**W. M. JORDAN COMPANY'S ADDENDUM NO. 2**

***PROJECT: THE WILMINGTON FOOD BANK CD SET***

***DATE: 12/7/21***

4. Revised civil drawings C-2.0, C-4.0, C-6.4, L-2.0. Included in this Addendum. See plan room.
5. Question: Will Penco be an acceptable manufacturer for the lockers?

**C-2.0**  
PEI JOB#: 20484.PE

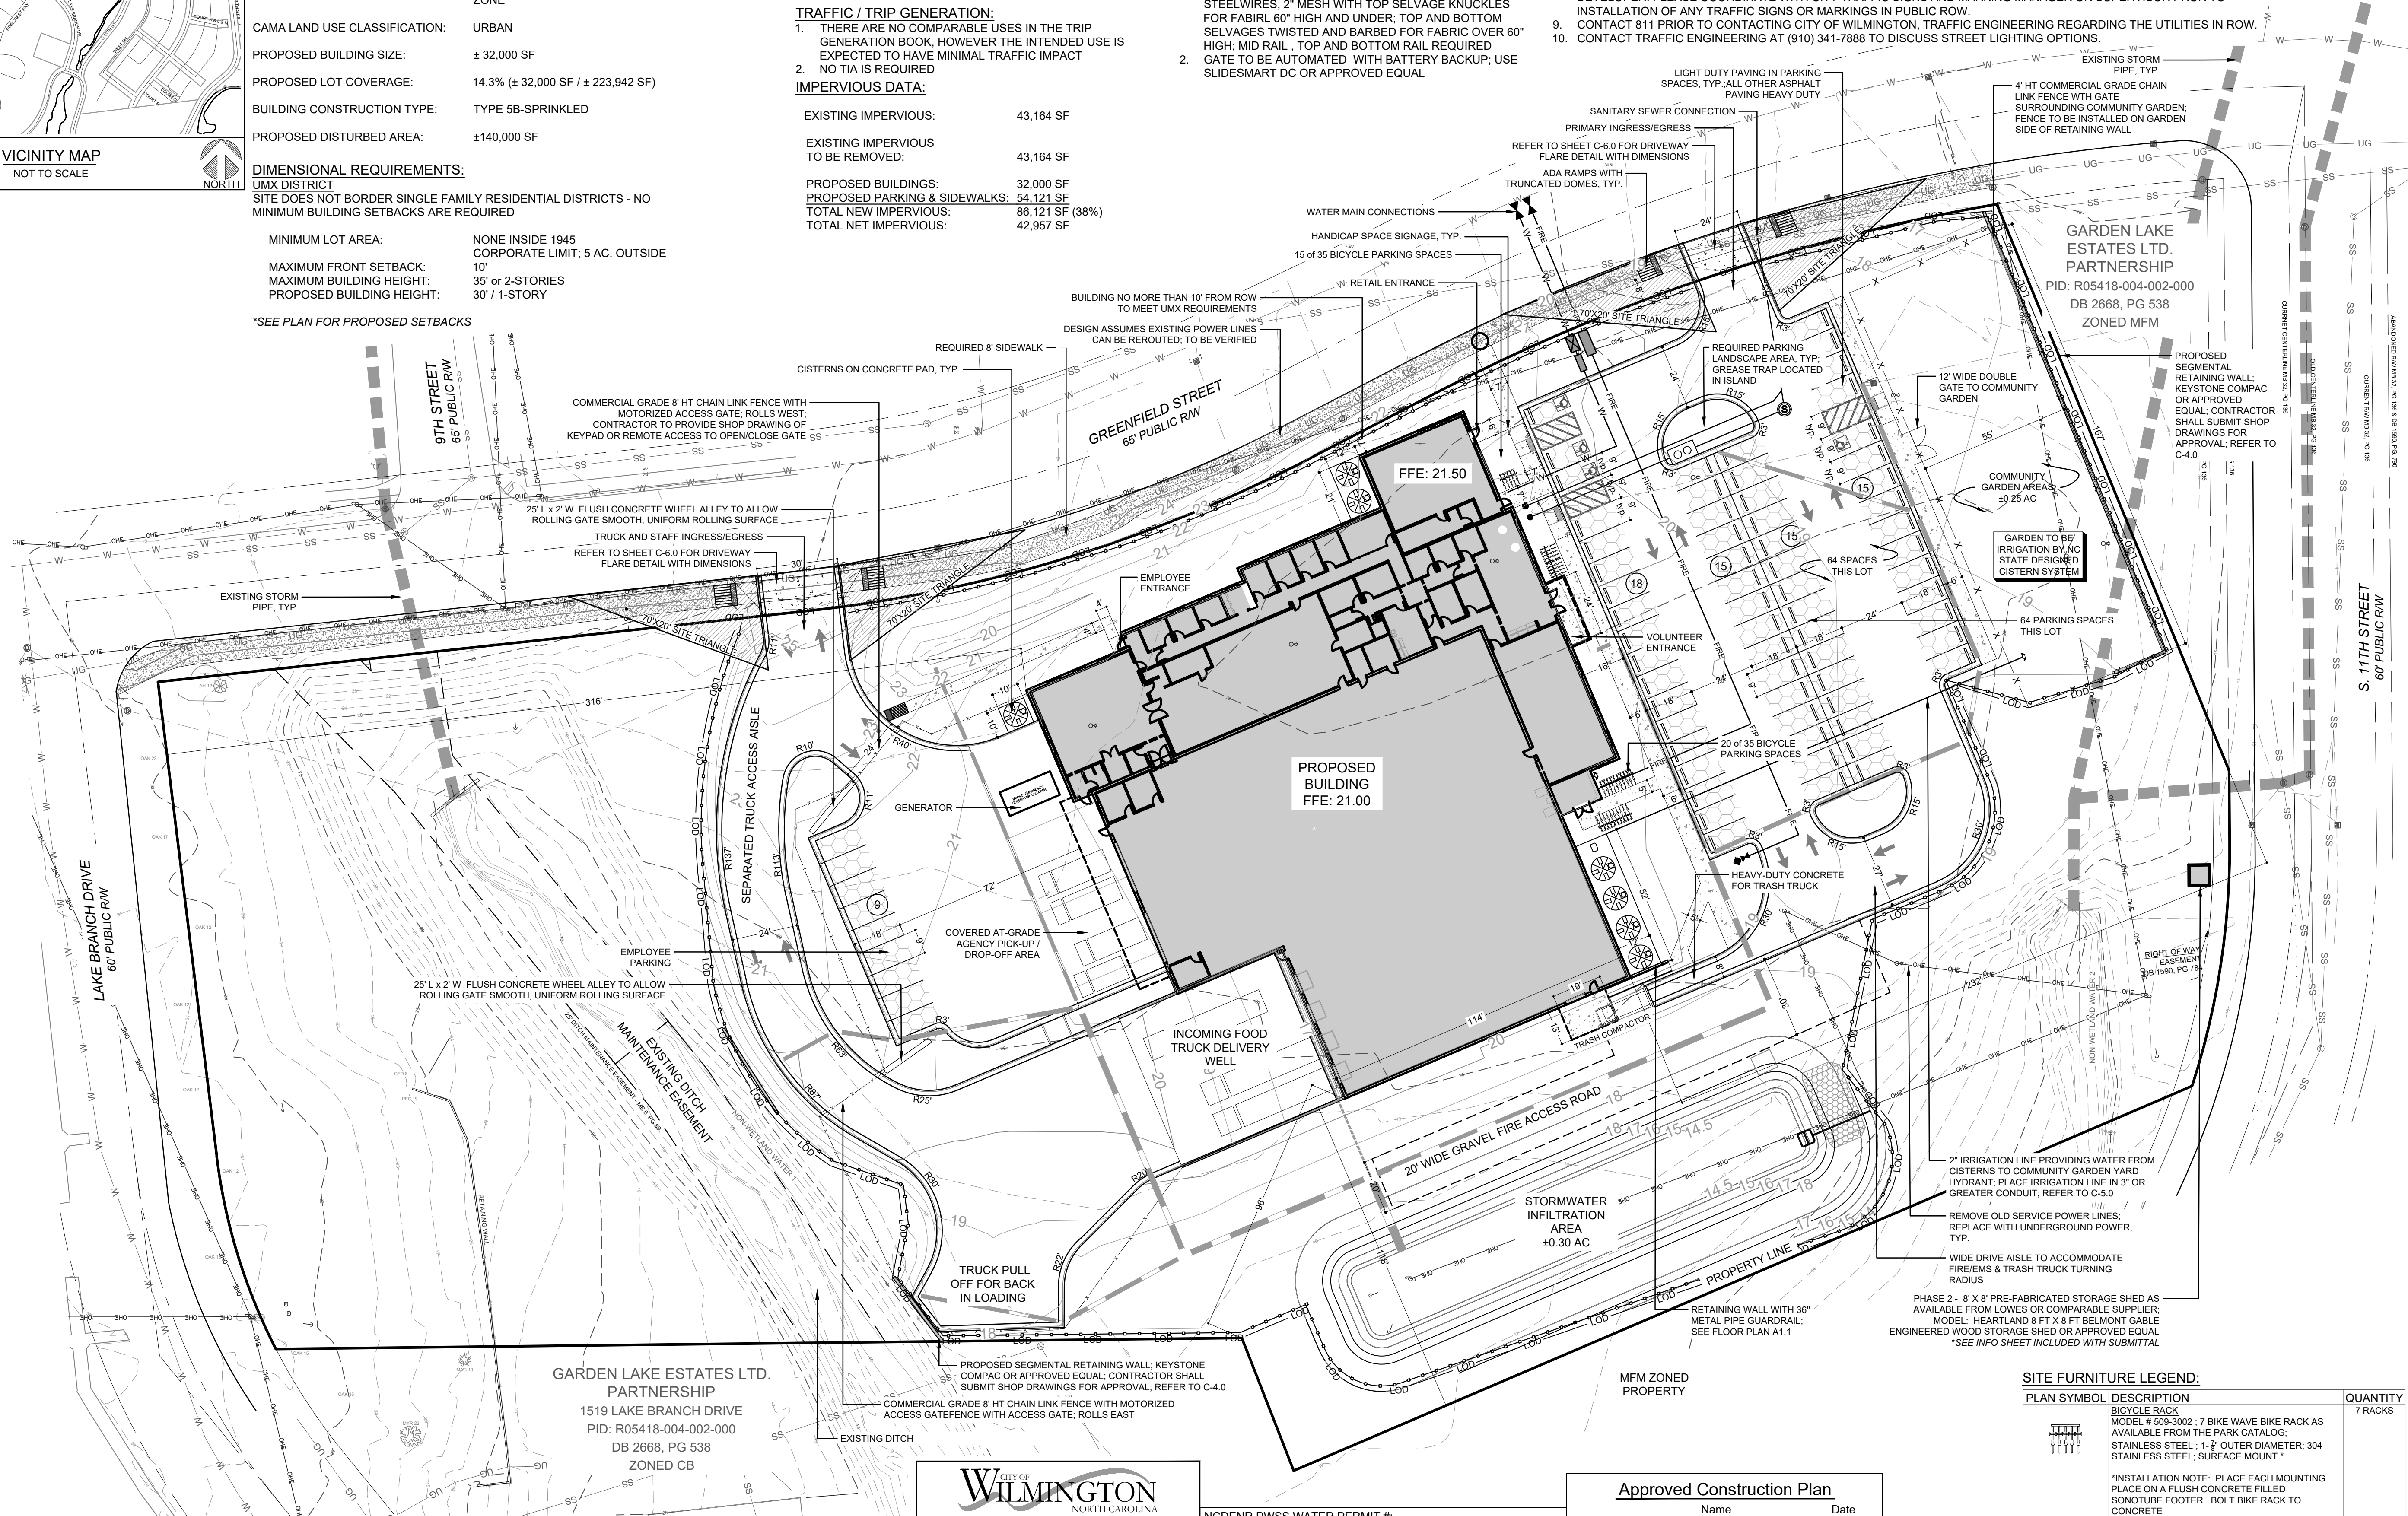
8. Question: Please provide a detail for the wheel alley indicated for the sliding gates.  
**Answer: Use sidewalk detail on sheet C-6.0 and follow note on C-2.0 for dimensions.**

10. Question: The trash compactor area concrete platform, pedestrian ramp and trash truck access dimension are in conflict on drawings C-2.0, A0.1, A1.5 and S2.1.  
Please verify the width and length of the concrete platform. Which design is correct?

Answer: Length and width has been added to C-2.0 and follows the length and width of the structural drawings.
11. Question: Sheet A1.5 shows the width of the trash truck lane to be roughly 11'6" while civil drawing C-2.0 show it much narrower with a strip of asphalt between the curbs at 5' which seems really narrow for a trash truck. Please advise?

Answer: C-2.0 has been updated to reflect the structural drawings design.
12. Question: Sheet C-2.0 calls for heavy duty concrete paving for the trash truck lane, but doesn't show dimensions on where it stops/starts vs asphalt. Please advise.

13. Question: Sheet A0.1 shows a 5' wide diagonal section of sidewalk from the end of the pedestrian ramp at the trash compactor meeting the sidewalk running parallel with the building. Civil C-2.0 doesn't show this sidewalk. Please advise if this extra sidewalk is needed?

15. Question: Please provide a bike rack specification and/or model #.  
Answer: Bike rack specification and model number has been added to C-2.0.
16. Question: Sheet C-2.0 shows aluminum fencing around the community garden. This fence was thought to be chain-link fencing through budgeting. Please advise if aluminum fencing is really wanted, or if it is chain-link. If aluminum, please provide detail.

Answer: The fencing around the community garden is chain link. see note on C-2.0. no detail needed.
17. Question: There are two site retaining walls shown on C2.0. The one near the "truck pull off area" mentions masonry, but the one beside the community garden does not mention type. Please confirm these are both segmental block retaining walls. If there are any specifics for these units please advise as there are no specifications associated with any site work.

Answer: Sheet C-2.0 has a note explaining that light duty paving will be used for all parking spaces on site while all other paving will consist of heavy duty, which includes travel lanes and the trash truck lane.

Answer: Civil drawing C-2.0 has been updated to match sheet A0.1 with the location of the extra sidewalk.
14. Question: The trench drain detail was added to sheet C-6.4 for the loading dock area, but the trench drain does not show up on the plan showing lengths, location, how it connects, where it drains to, etc. Please advise.

Answer: A note has been added to C-2.0 confirming segmental block retaining walls and references sheet C-4.0.

C-4.0

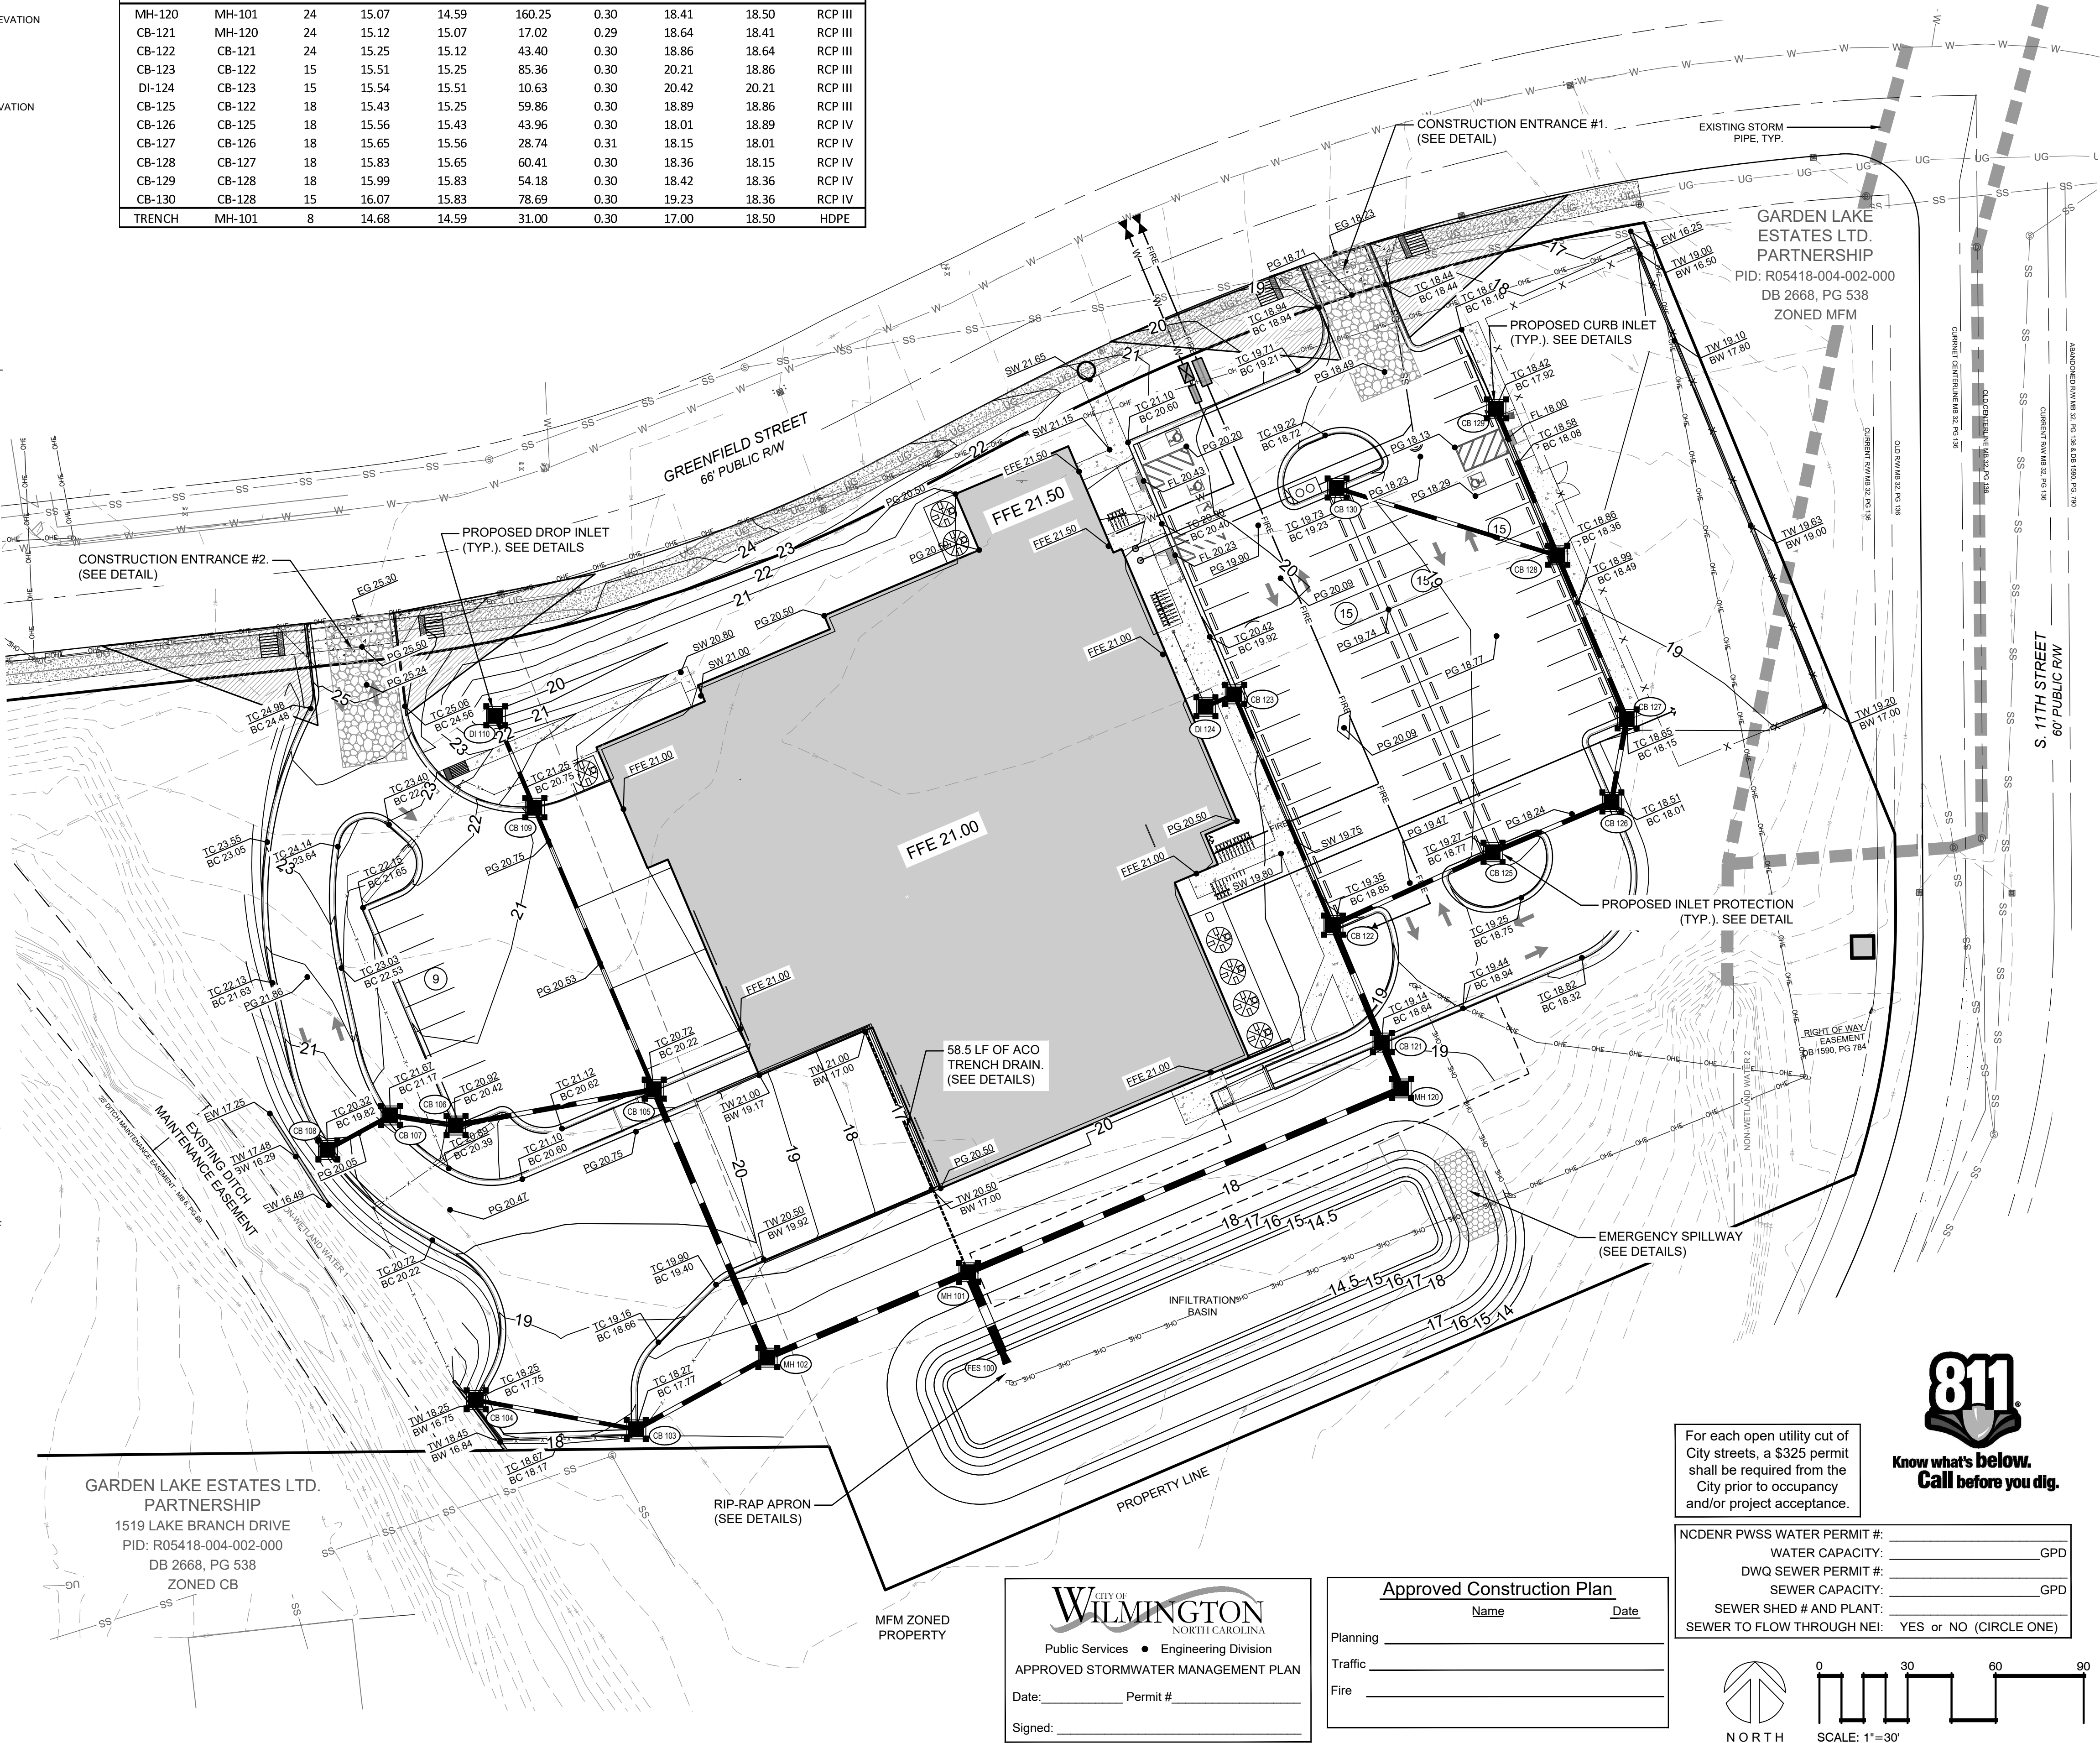
18. Question: The retaining wall near the "truck pull of area" does not give height. Please advise.

Answer: A note has been added to sheet C-4.0 describing the type of drain, length, and where it drains to as well as truck well pump detail on C-6.4. BP-31A to include in their scope of work.

Answer: Revised sheet C-4.0 give top of wall and bottom of wall heights.

**TRENCH DRAIN DETAIL**

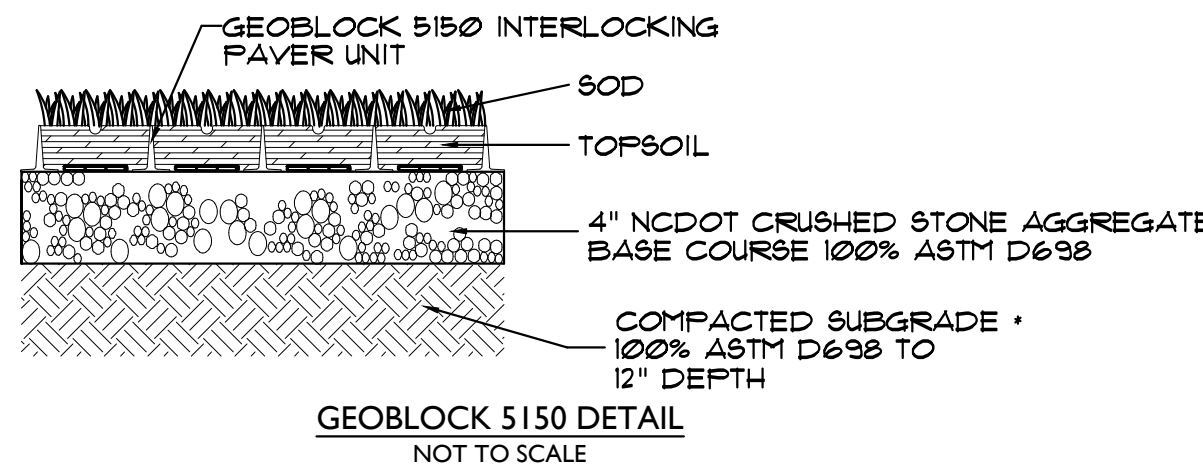
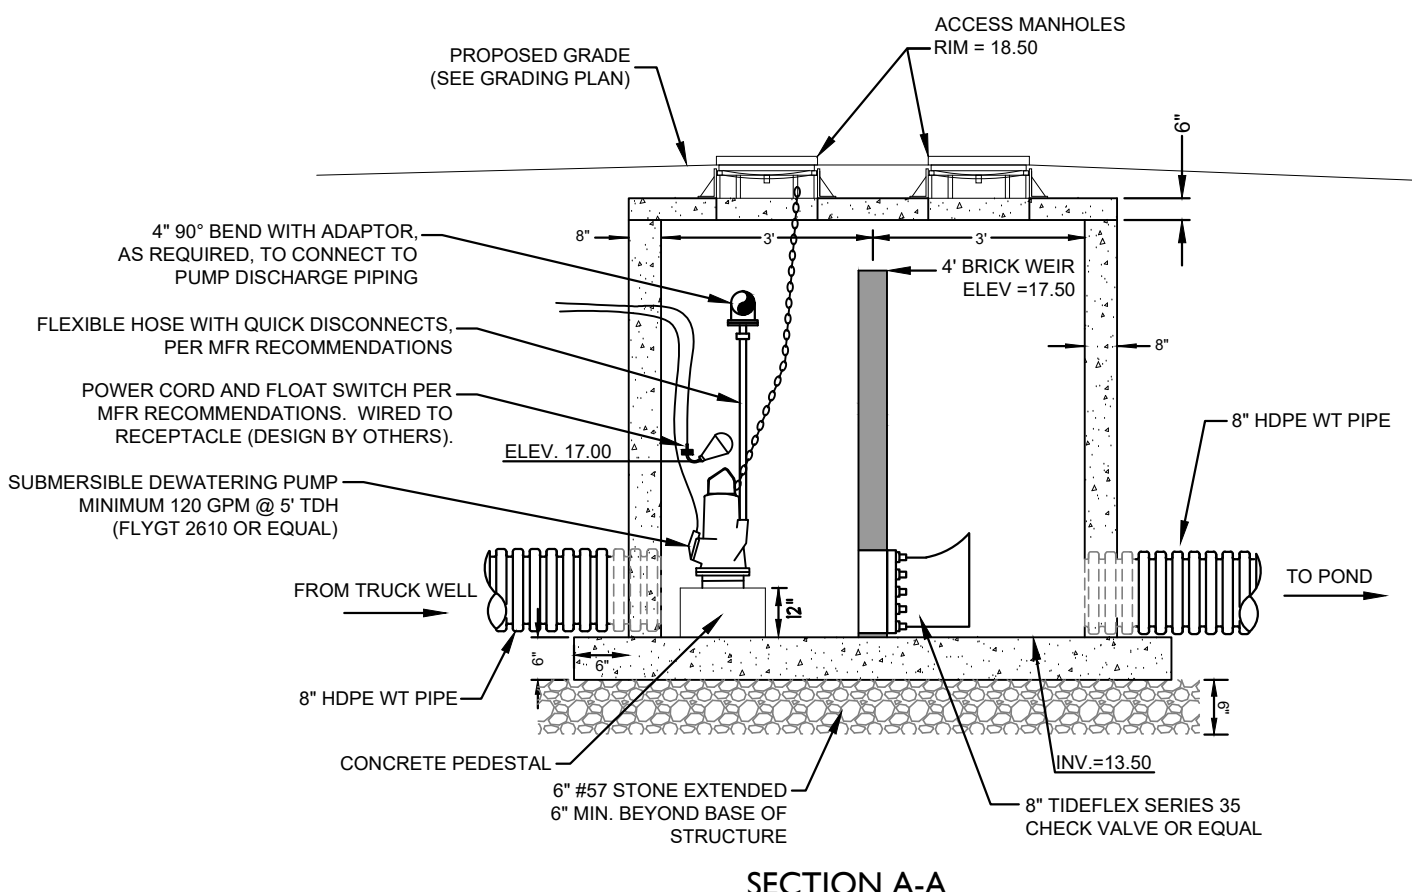
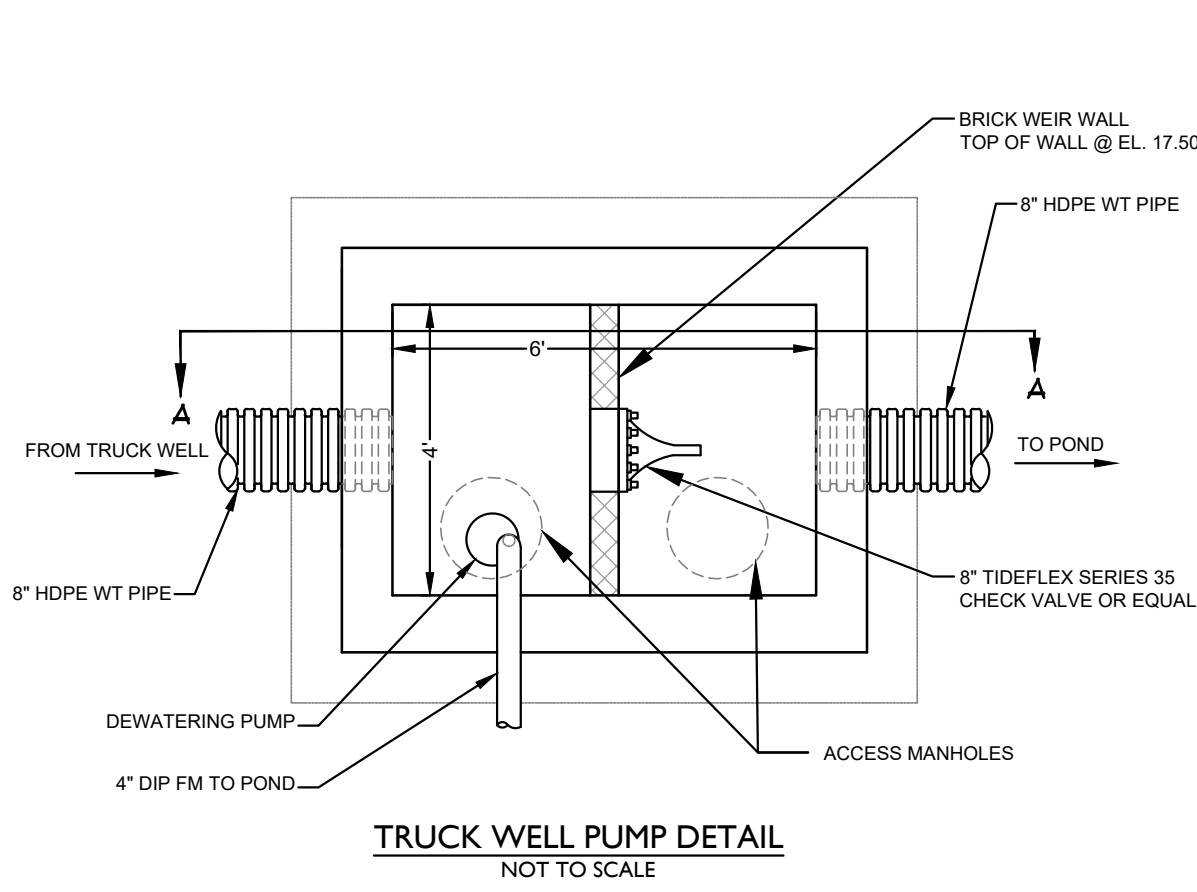
7. Question: Please provide a detail for the 20' gravel drive in regards to stone thickness and any fabric or geogrid required.  
**Answer: A detail has been added to C-6.4. BP-31A to include stone, topsoil as shown. BP-32A Landscaping to include SOD as shown.**
